Docket Nos. 50-354  
50-272  
50-311

Subject: Federal Emergency Management Agency (FEMA) Evaluation Report of the  
Alert and Notification System for the Artificial Island Nuclear  
Generating Stations

ARTIFICIAL ISLAND NUCLEAR GENERATING STATIONS  
SITE-SPECIFIC OFFSITE RADIOLOGICAL  
EMERGENCY PREPAREDNESS ALERT  
AND NOTIFICATION SYSTEM QUALITY  
ASSURANCE VERIFICATION

FIGURE 3

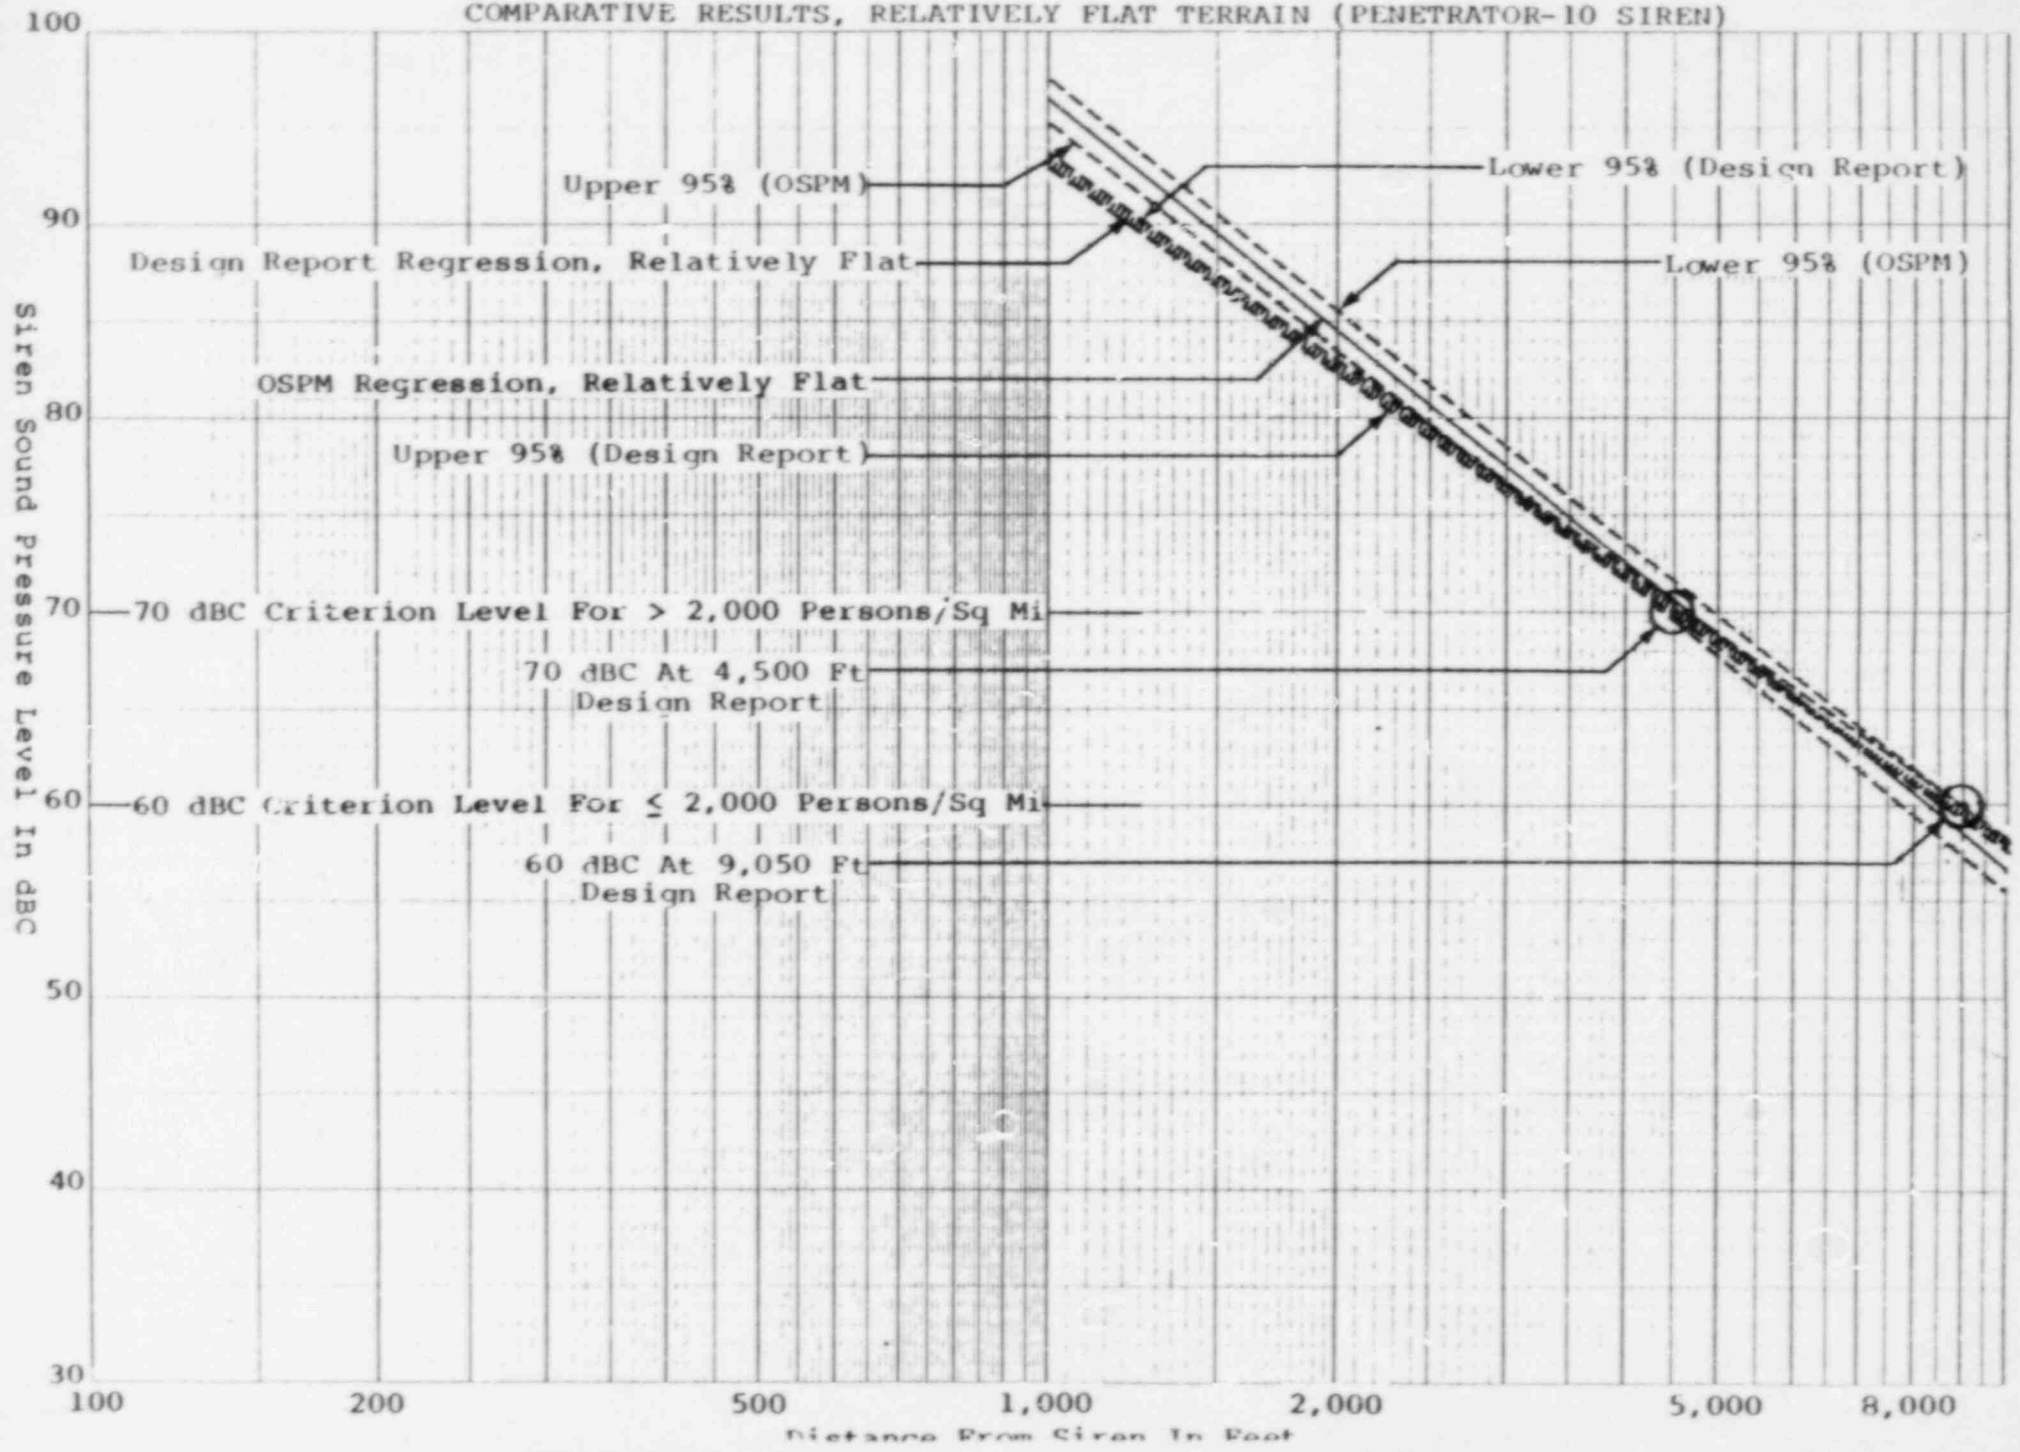
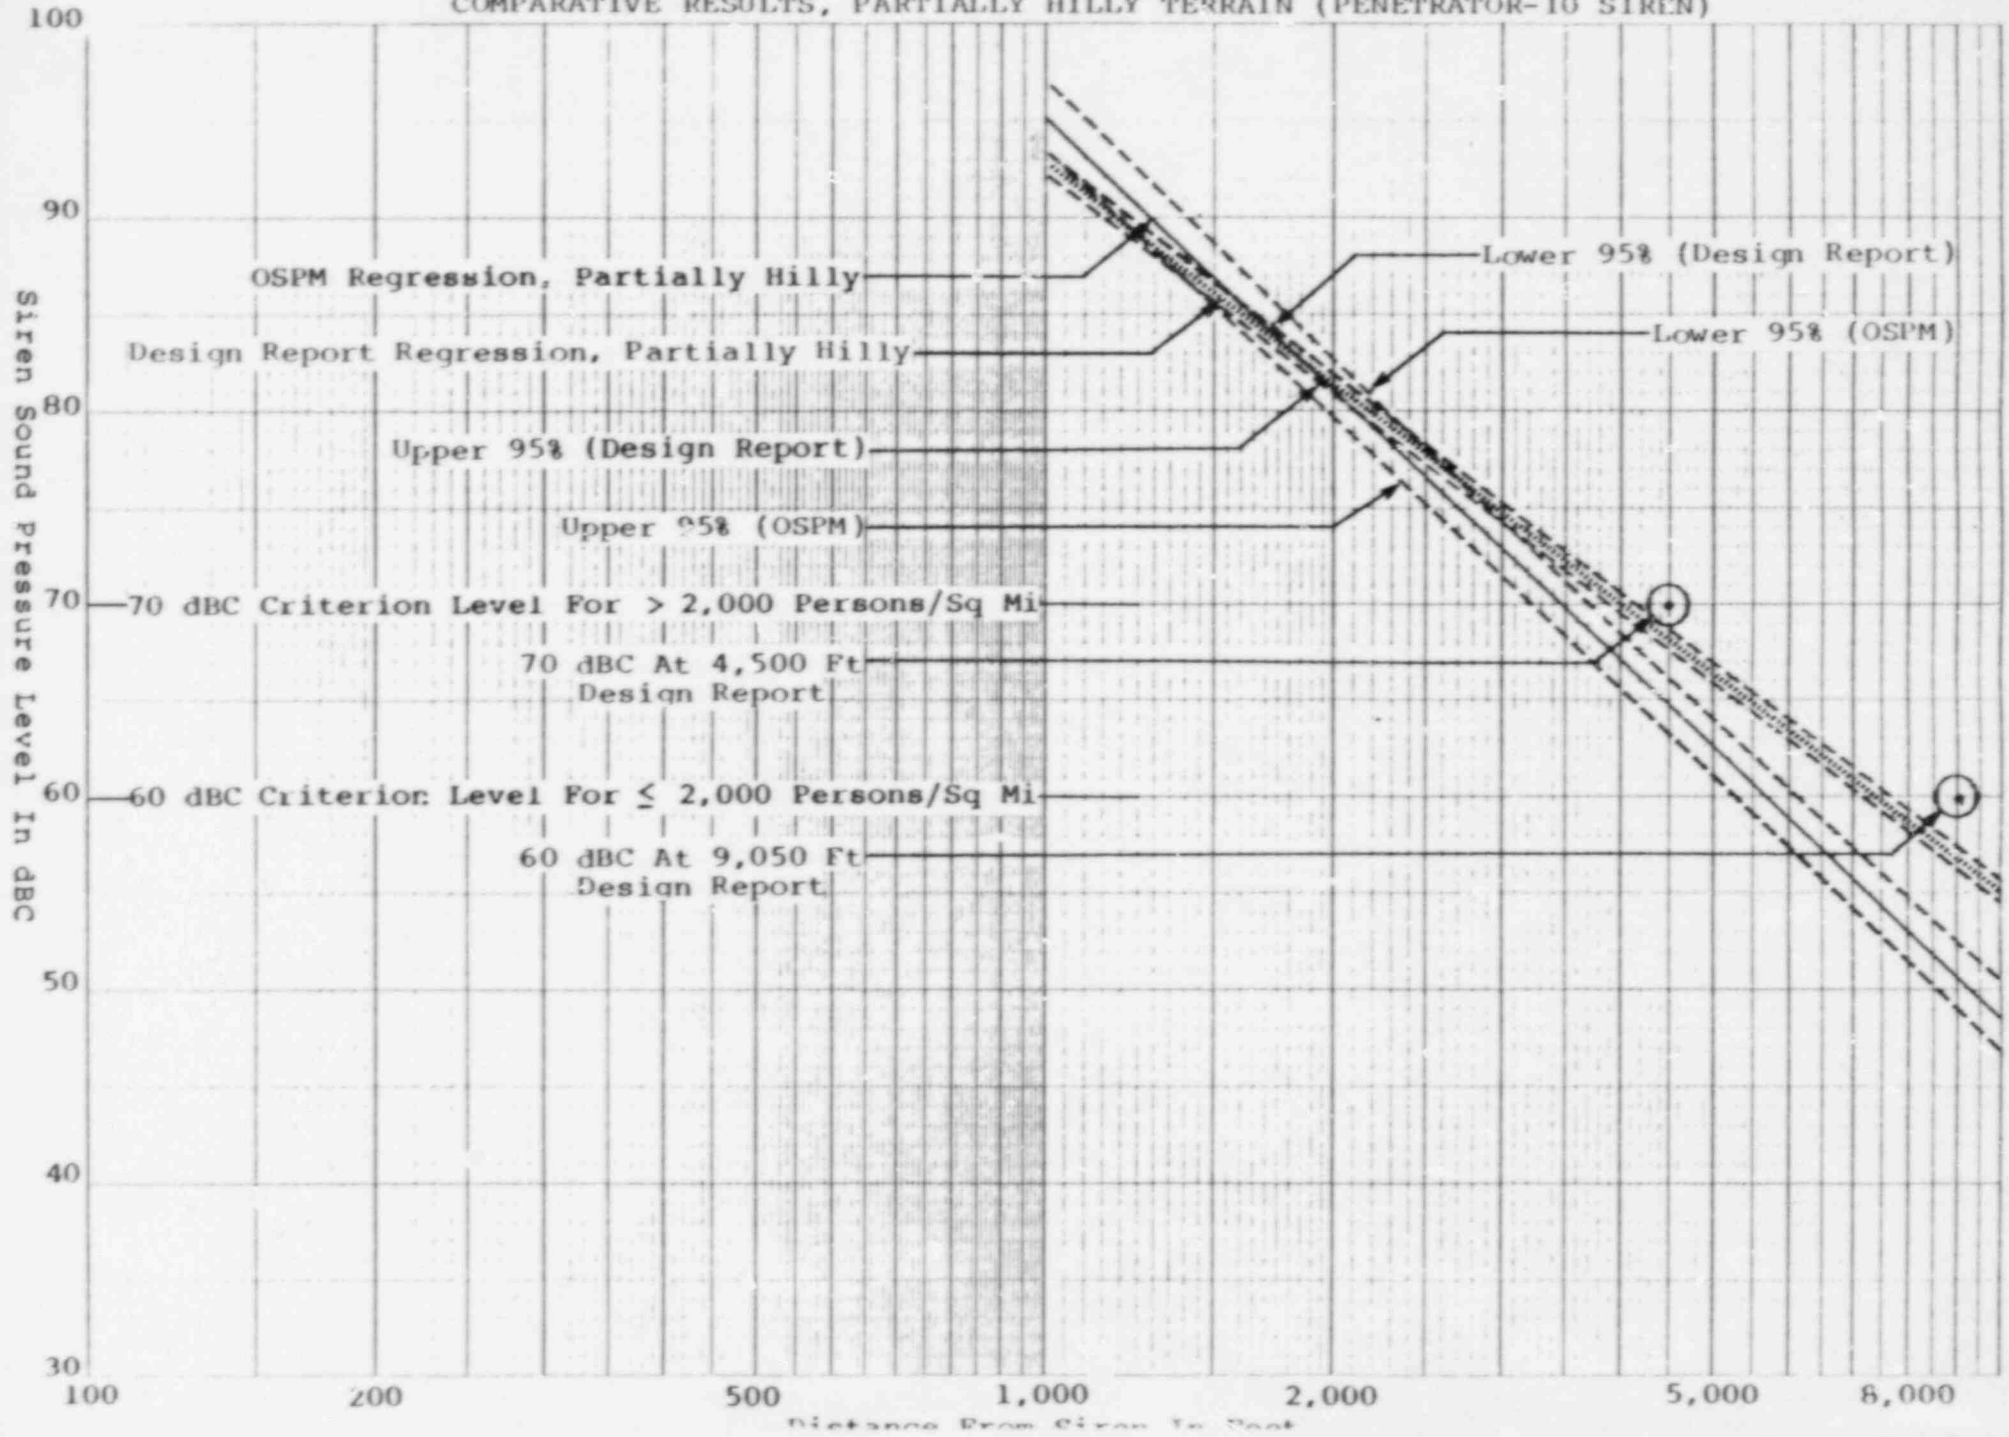
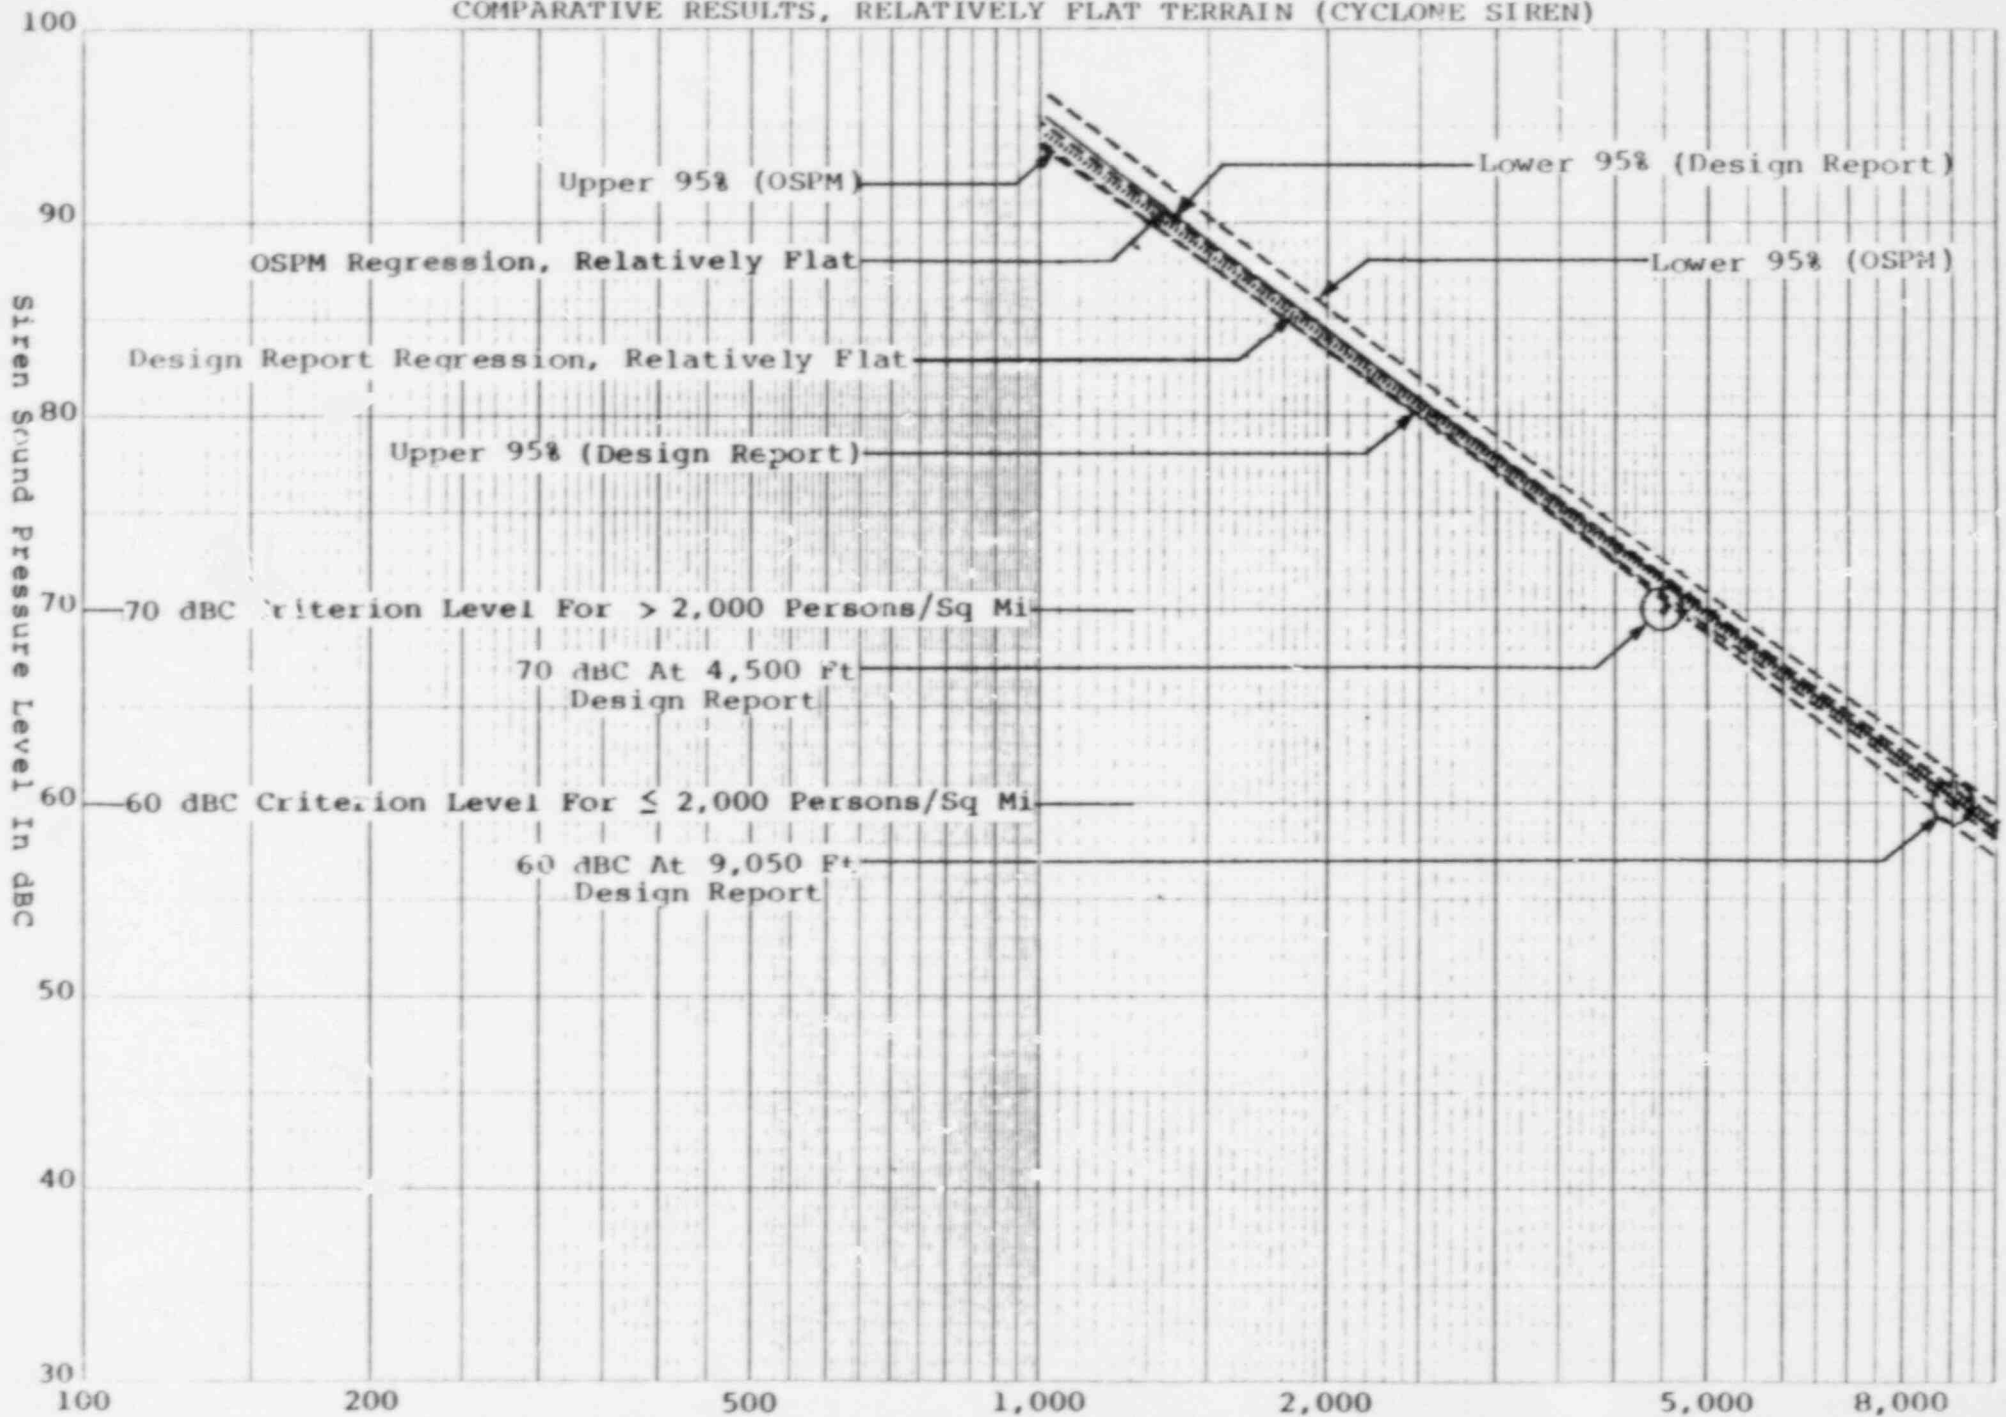
It can be seen from Figures 3 through 5 of this report that the effective 70 dBC and 60 dBC range estimates provided by the design procedure are similar

compared to OSPM predictions for relatively flat site-specific terrain conditions for the Penetrator 10 siren. The Design Report ranges are liberal compared to the OSPM-derived ranges for the partially hilly category. The effective 70 dBC and 60 dBC range estimates for the Cyclone sirens provided by the licensee's design procedure are very close to OSPM predictions for the relatively flat category.

Thus, in the presence of the prevailing site topographical and meteorological conditions, the design procedure is judged to be adequate in estimating the effective 70 dBC and 60 dBC siren range.
